**GULF STATES UTILITIES COMPANY**

River Bend Station - Unit 1  
Docket No. 50-458

Gulf States Utilities Company (GSU) submits the attached Emergency Procedure Guideline (EPG) deviation justification forms as requested in the Nuclear Regulatory Commission's (NRC) Safety Evaluation Report (SER) Section 13.5.2.3, Confirmatory Item No. (60). To assist your review, the following information is attached:

RBS EPG Deviation Justification  
Forms on Technical Matters

FIGURE B

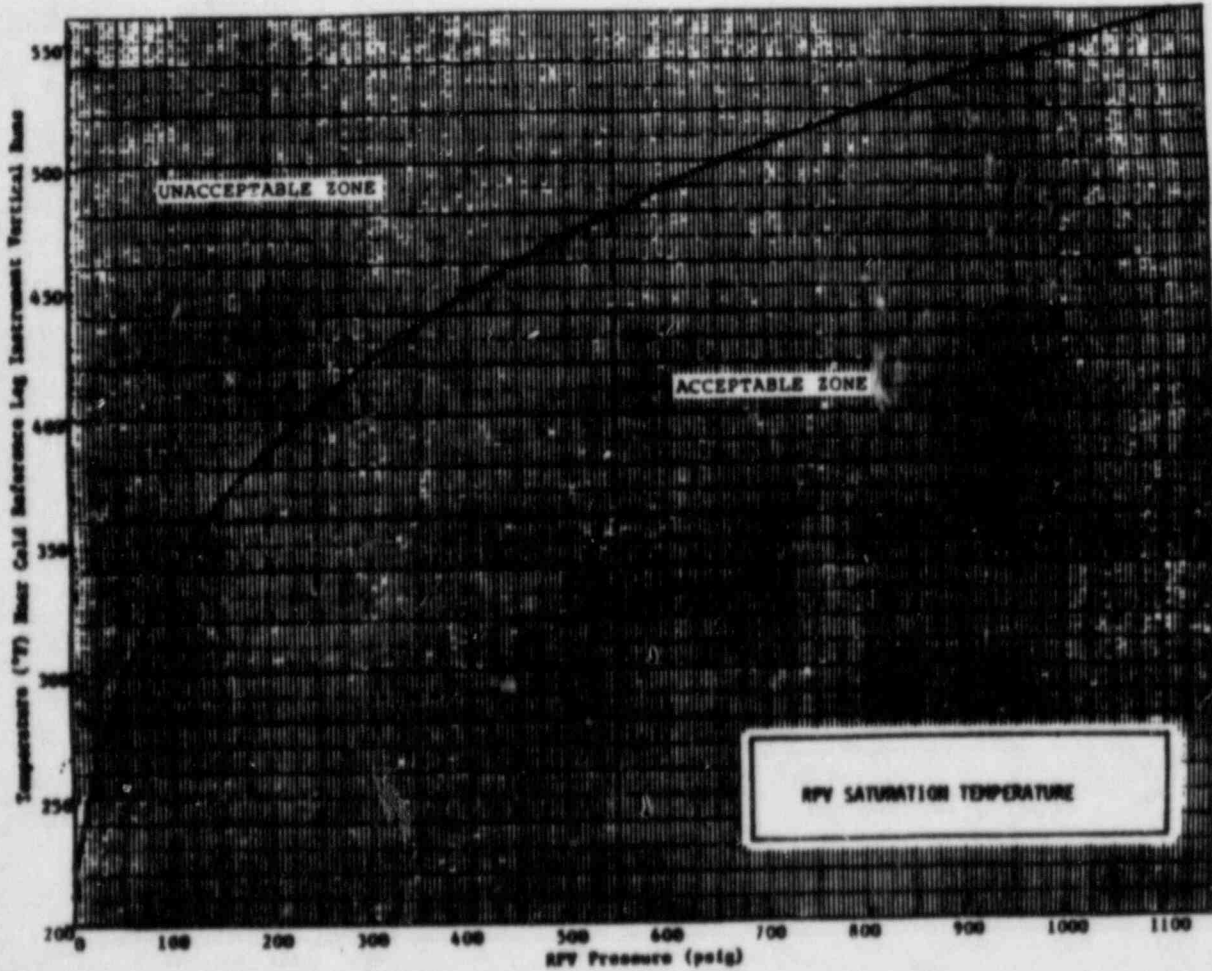
EPG STEP: DW/T-2

EOP STEP: EOP-0002, Caution 6 Added

Caution #6 was added based upon earlier RBS design. The RBS design has been changed and Caution #6 will be deleted.

Suppression Pool Load Limit

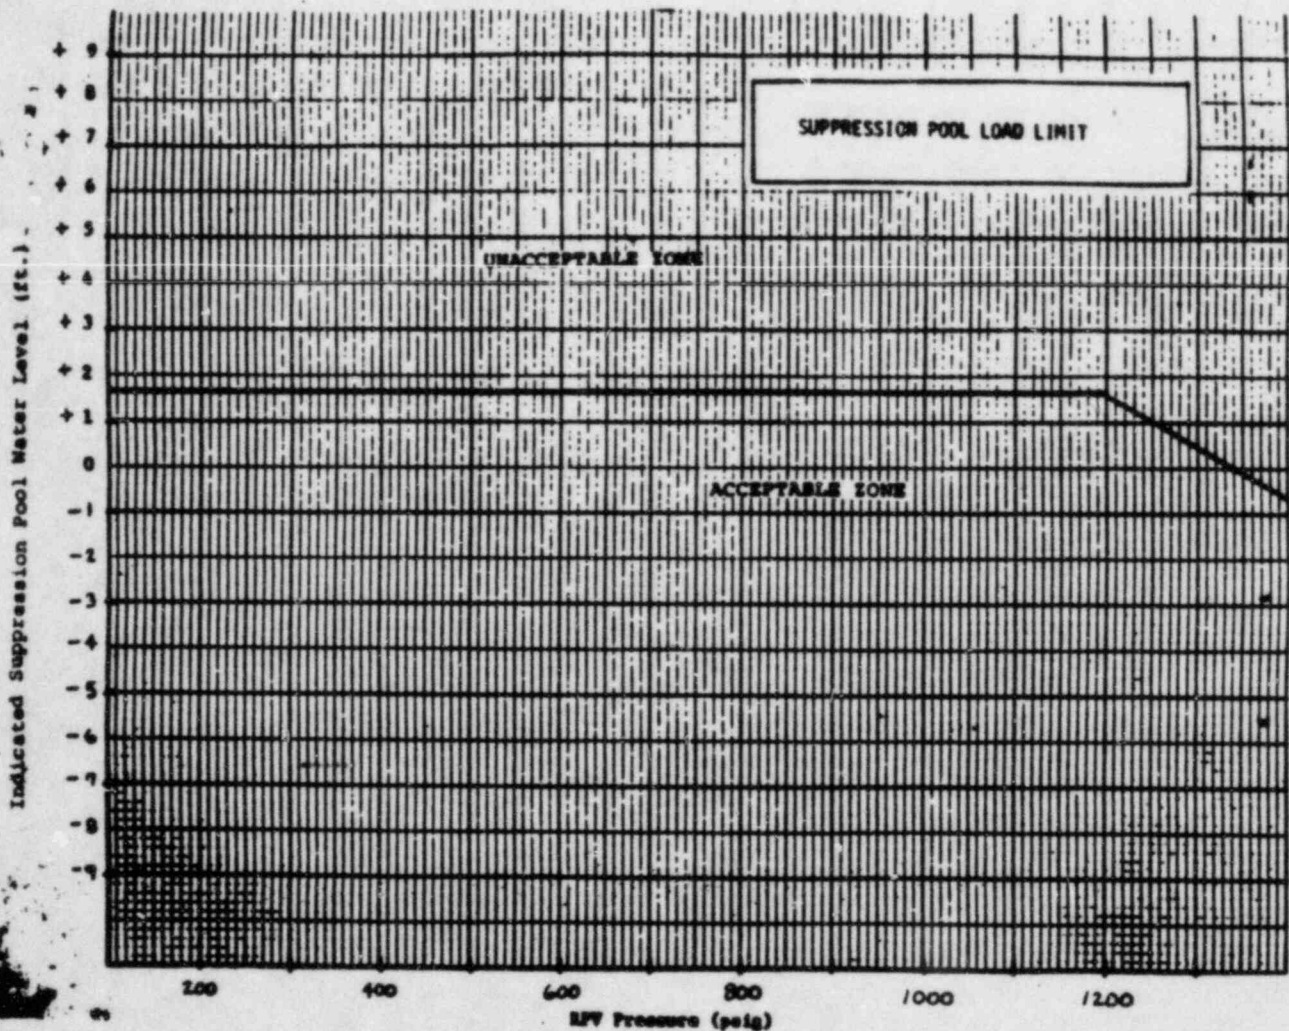
EPG STEP: SP/L-3, Note.

EOP STEP: EOP-0002, Step 3.5.3 & 3.5.4

Due to the plant specific configuration of the suppression pool load limit curve, Step 3.5.3 and 3.5.4 will be performed consecutively rather than concurrently.
